City of Bixby Planning Commission Meeting Agenda

Monday, October 17, 2022

- 2) Discussion, consideration and possible vote to approve Site Plan (BXSP-22.06) for Bullalo Wild Wings located North of 115th Street South and West of South Memorial Drive, Bixby, Oklahoma (11500 - Block South Memorial Drive).
O.C. Walker, City Planner

C1

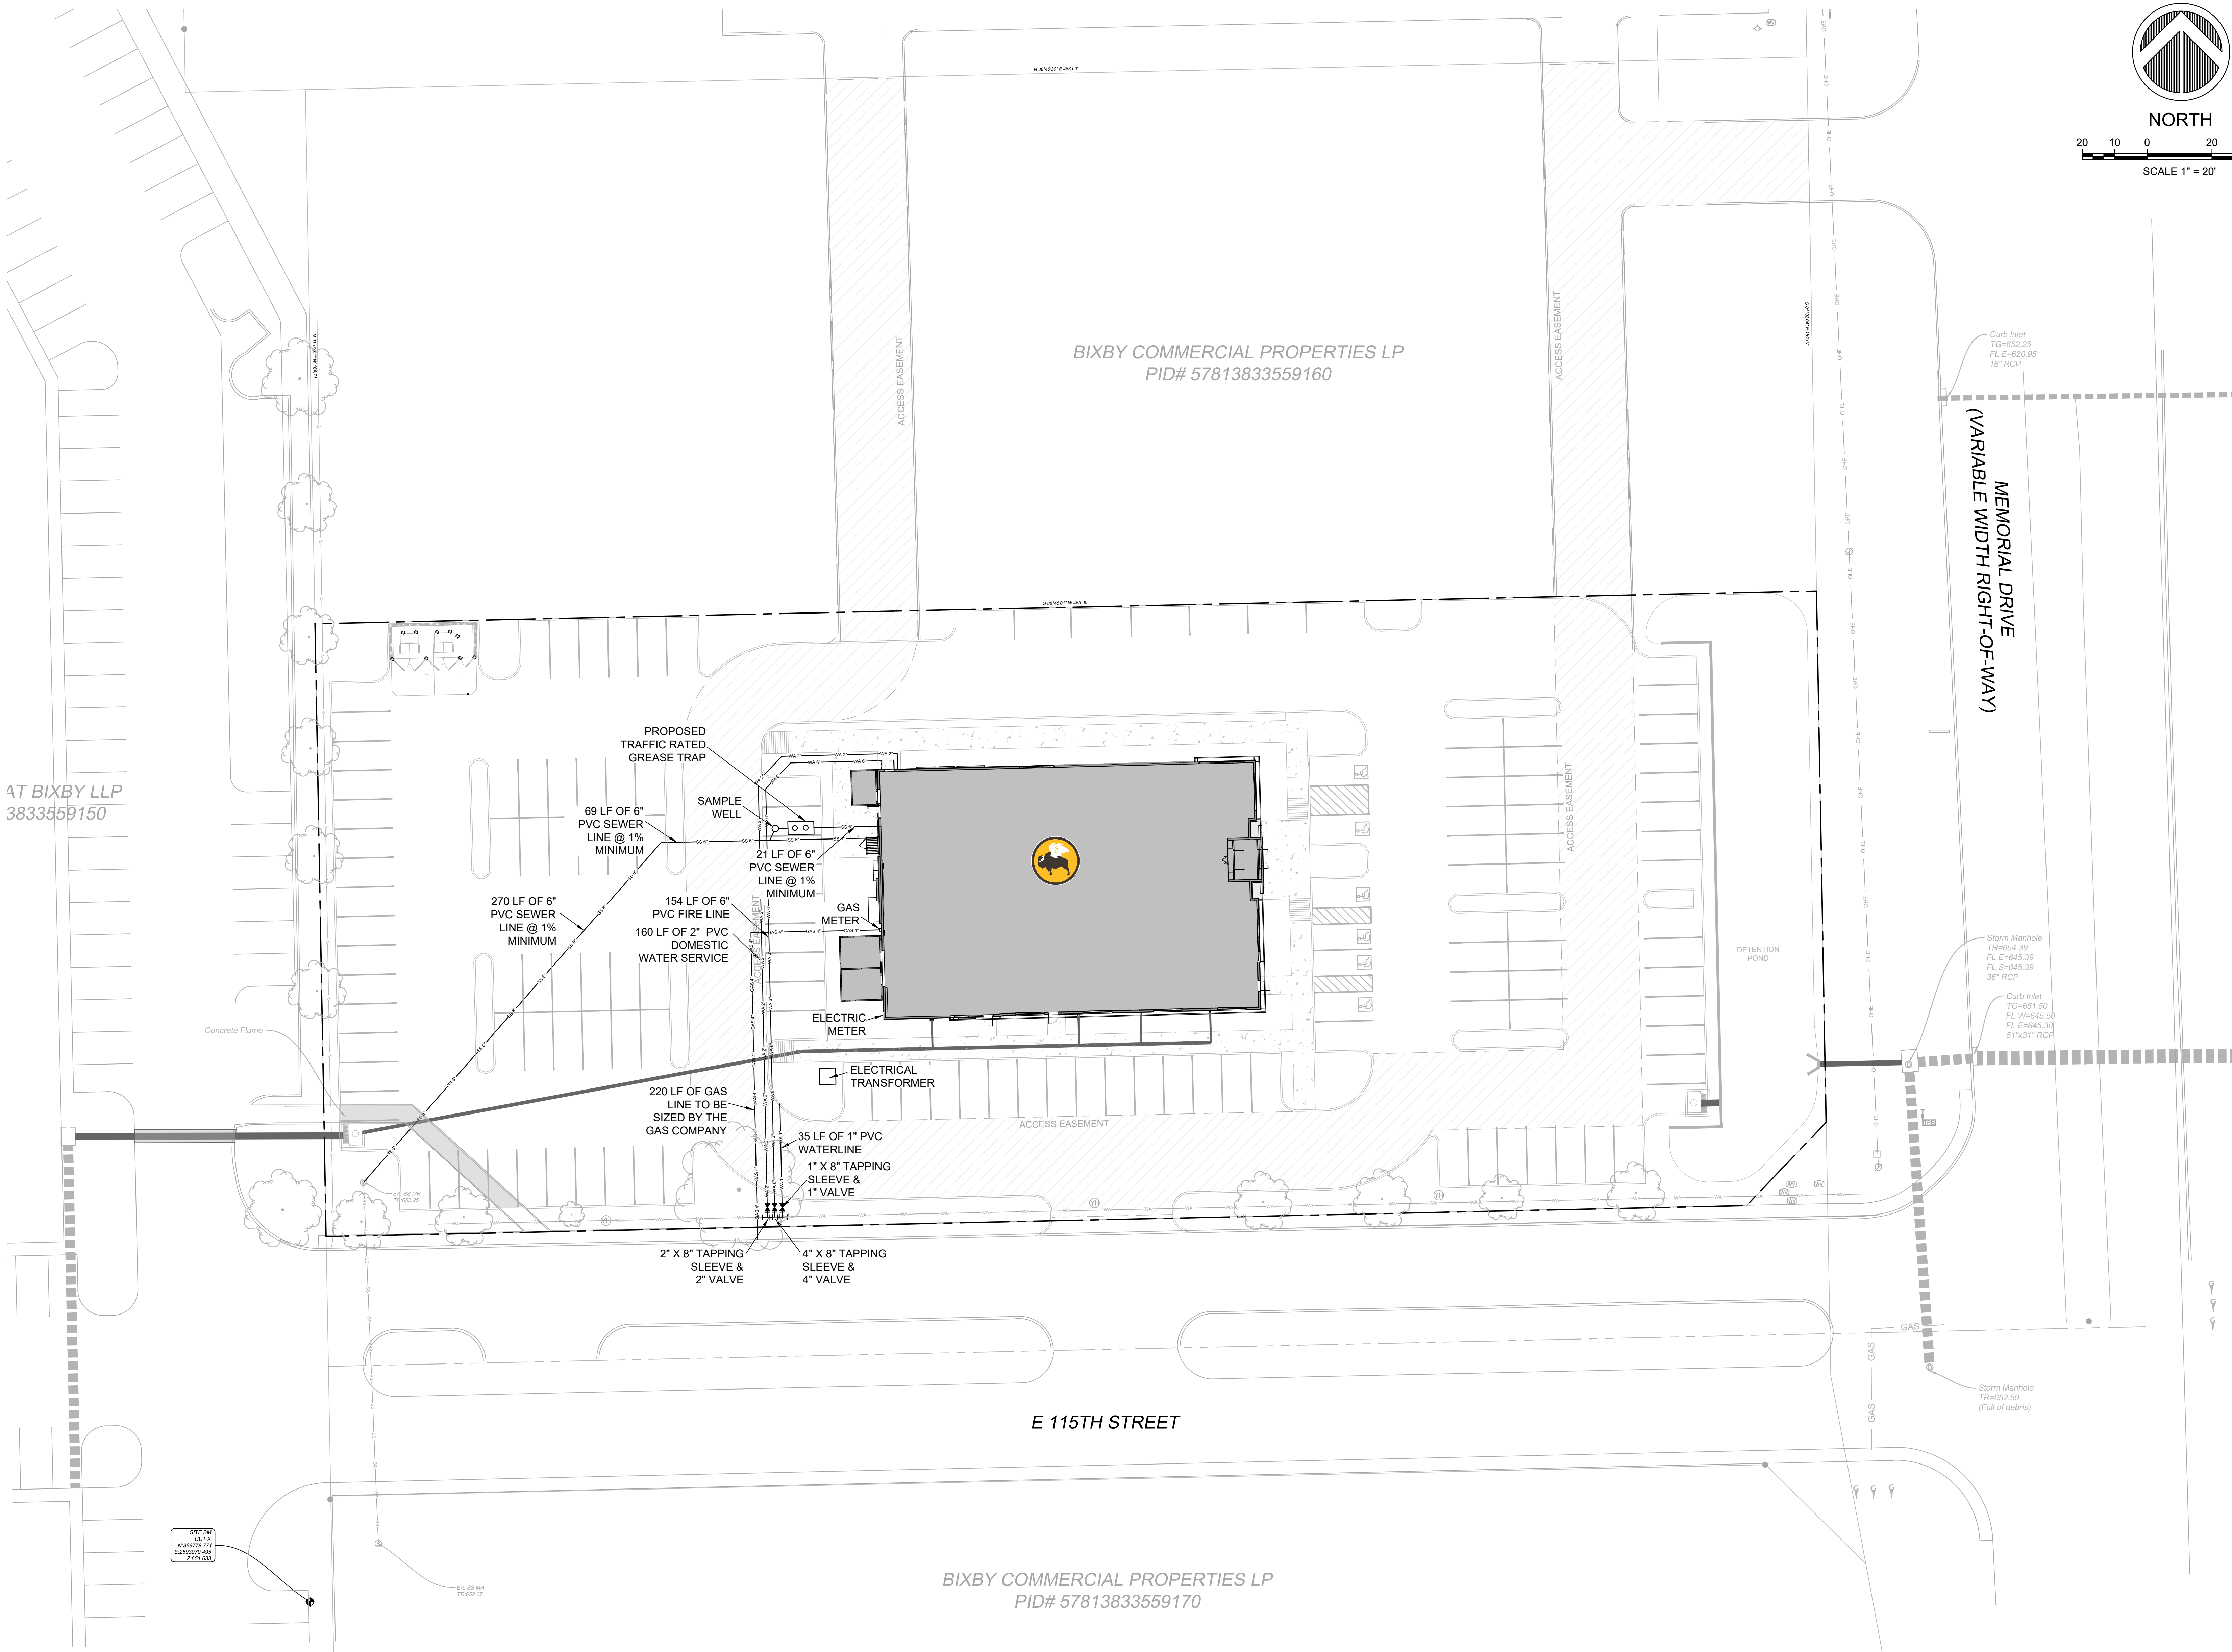
Staff Review: All lighting and landscape shall be in accordance with zoning regulations. Provide a mutual access easement to the North of site.

- Make all dimensions legible and readable.

Planned Unit Development No. XXX

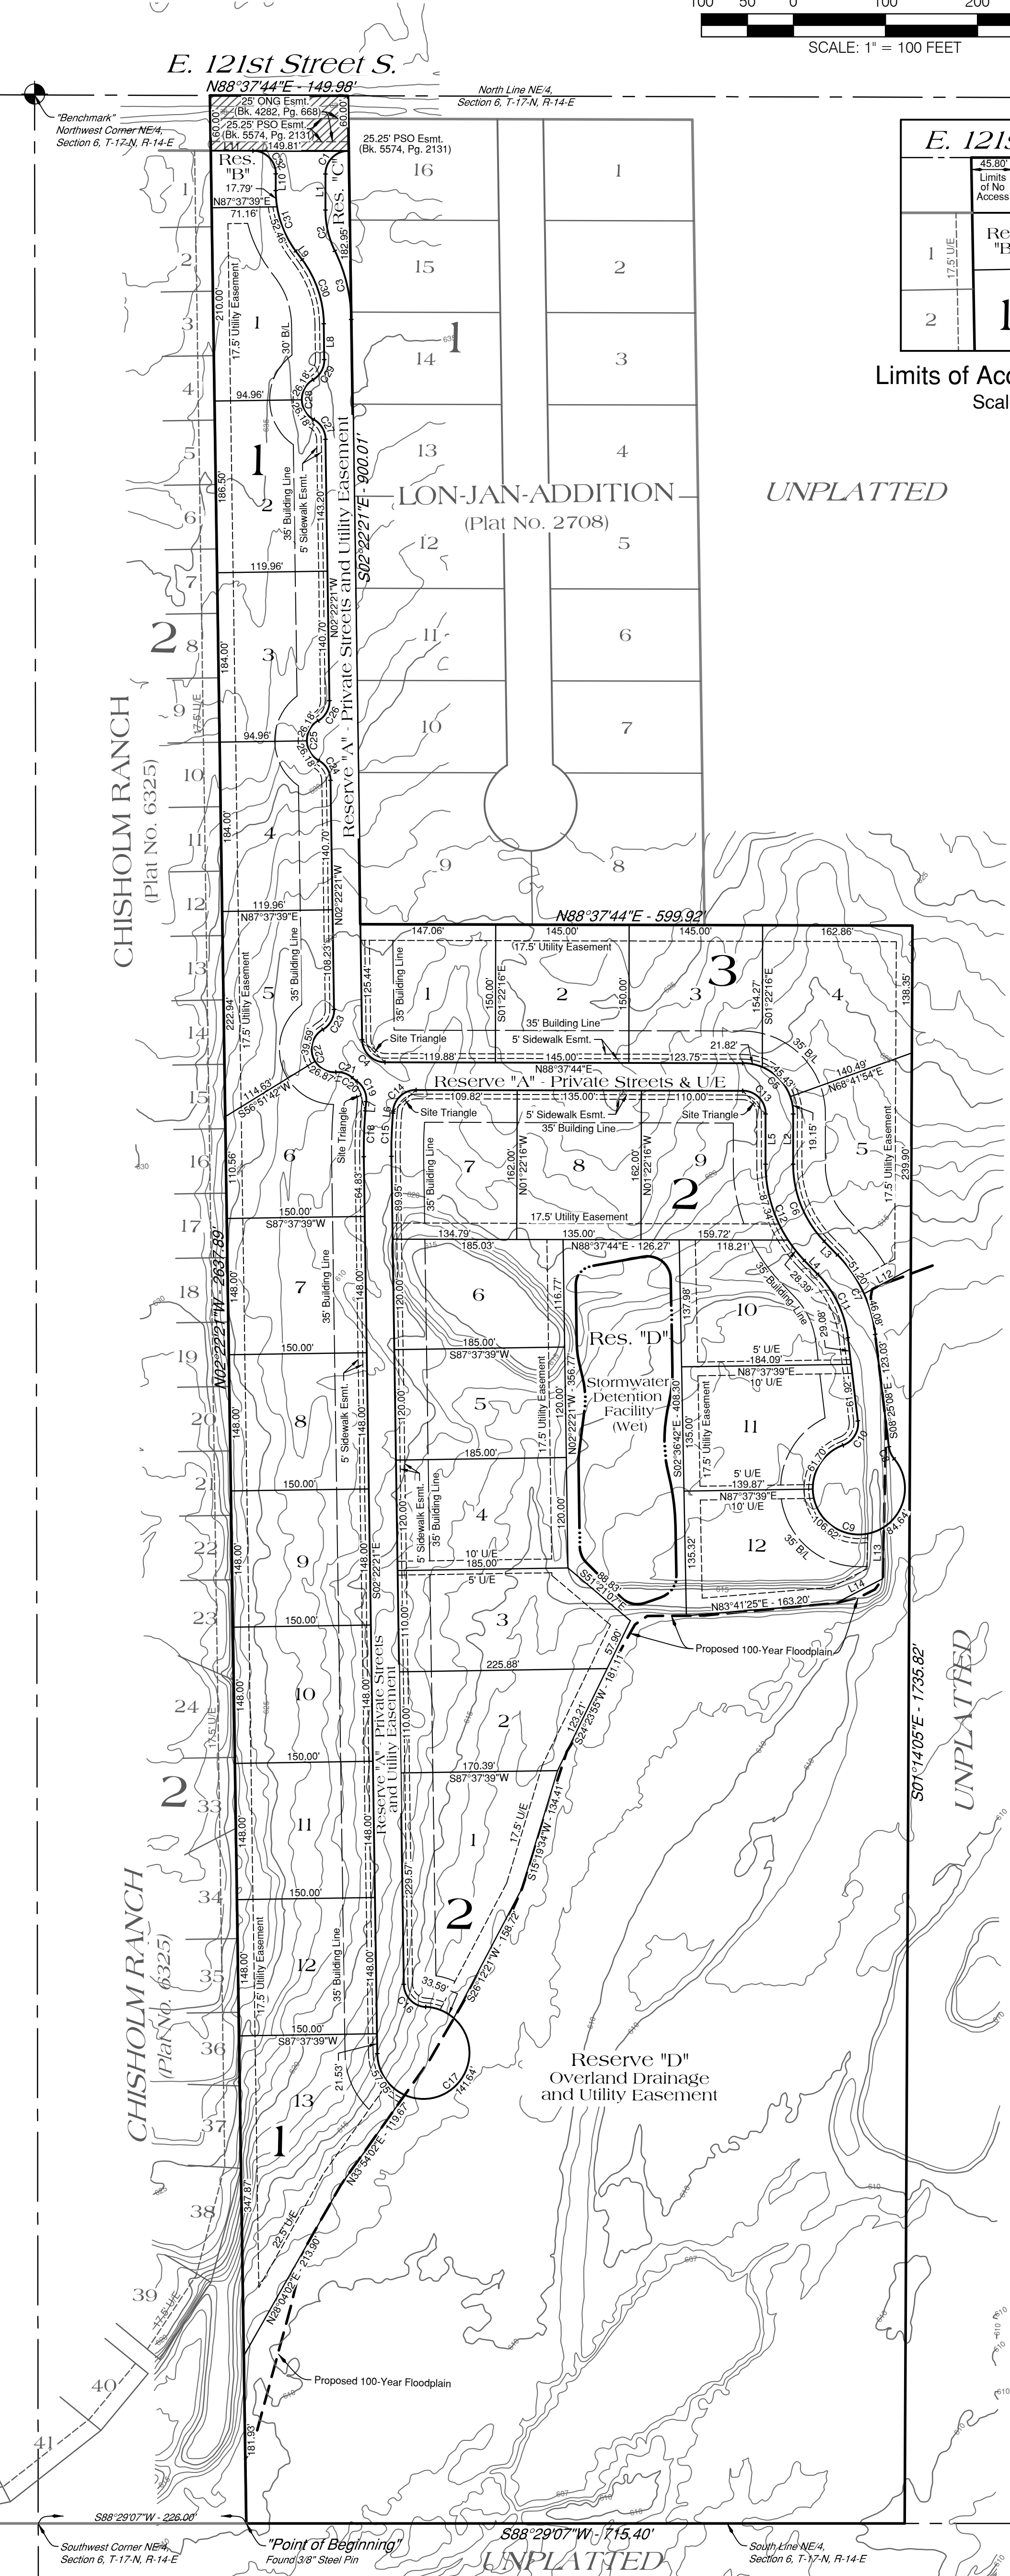
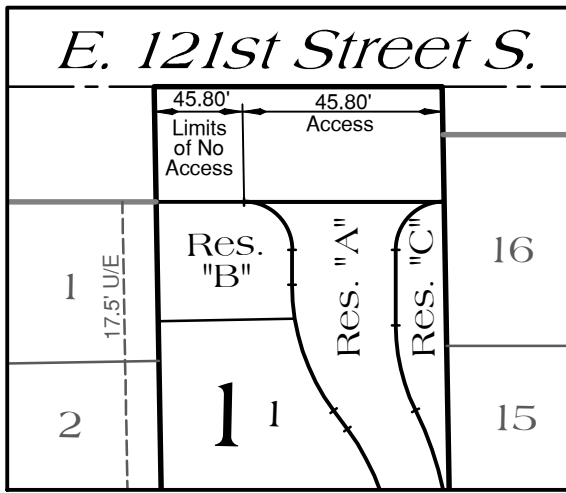
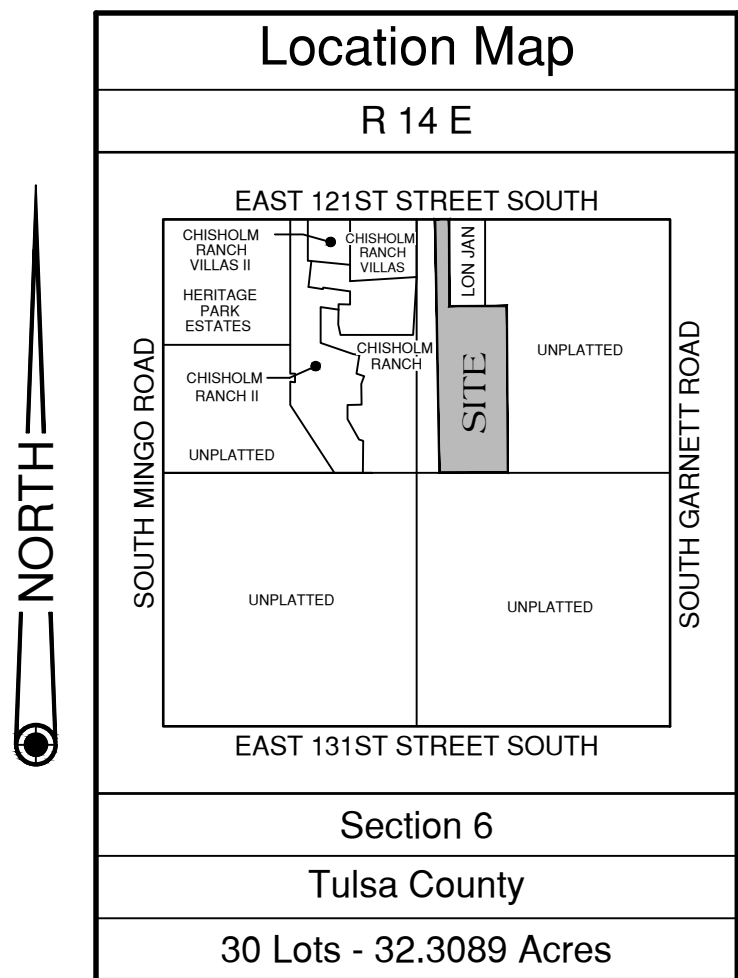
1. Final Plat stamp will need to be removed from the Preliminary Plat and Concept Utility Plan (page one)
2. Storm Sewer shall be labeled "private"
